SERVICE BULLETIN

M-1104

IGNITION SWITCH AND KEY KIT FOR 2000 MODEL SPORTSTERS

Figure 1. Kit Contents, Part No. 94030

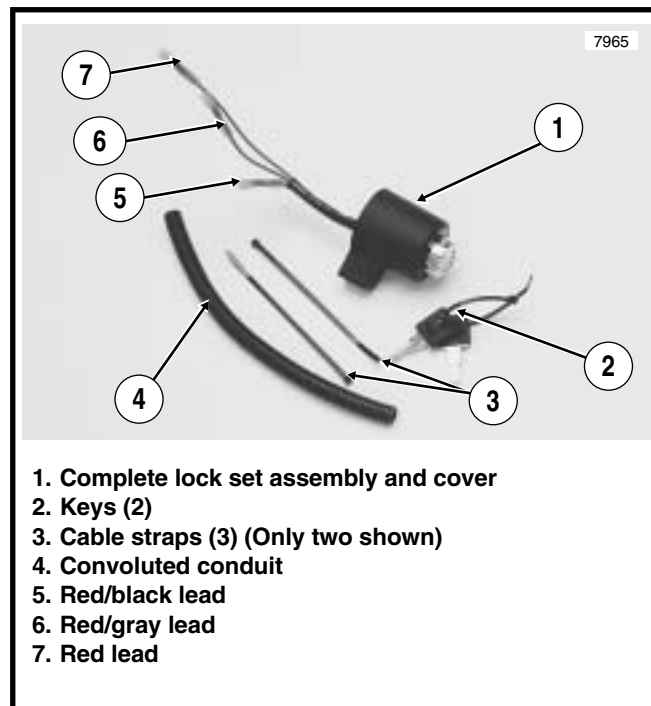
See Figure 1. Special ignition switch kits, P/N 94030, to facilitate this repair have been authorized. Enough kits to service all motorcycles listed in the above letter will be sent to your dealership.

Figure 2. Ignition Switch

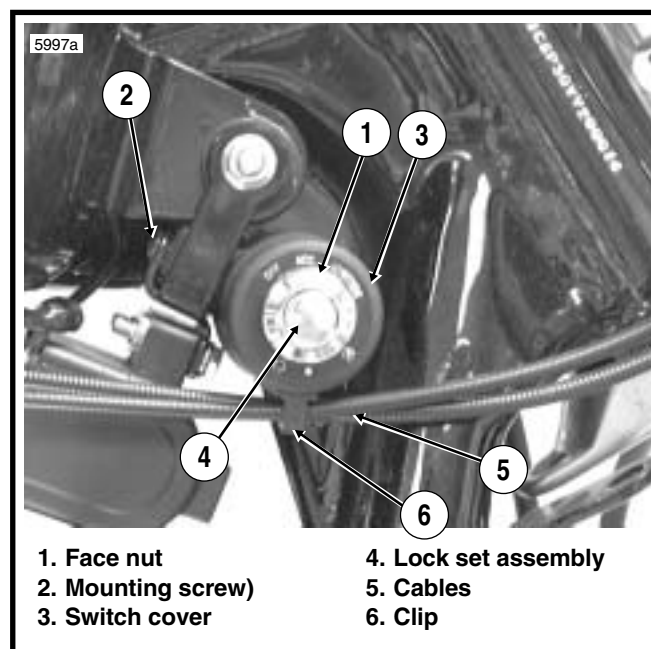
1. Remove seat.
2. Disconnect battery cables, negative cable first.
3. See Figure 2. Remove ignition switch face nut (1).
4. Remove Fuel tank. See FUEL TANK REMOVAL, Section 4 of 2000 XLH Service Manual.

- Remove mounting screw (2) and save for new switch assembly. Remove throttle control cables (5) from retaining clip (6) on switch cover (3). Slide switch cover off lock set assembly
